**BID: FR-23
SMOAKS FIRE STATION 7
RENOVATION and EXPANSION**

**ADDENDUM 1
DATED: DECEMBER 10, 2019**

Z1072

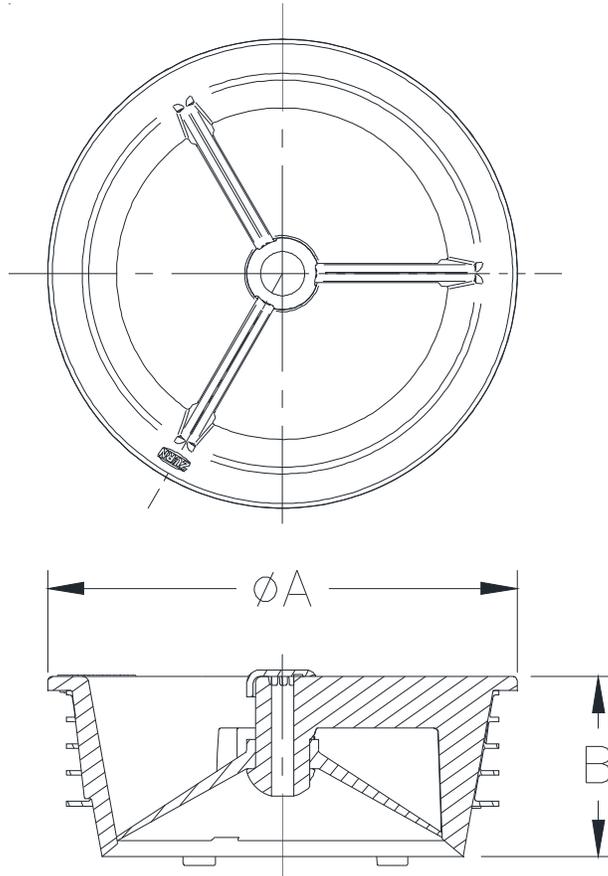
- 3) The report also notes that Liquefaction is present. How would you like us to prepare our proposals for this? **Answer:** The structural design takes into account the findings and stated recommendation in the report. The structural general notes that all site preparation shall be per recommendations of the Geotechnical Report (to include 4" granular layer below the footings and slab).
- 4) Can Zurn TG33 trap guards be used in lieu of trap primers? **Answer:** If a trap guard is used in lieu of a trap primer, it has to be ASSE 1072 certified, such as the attached product.
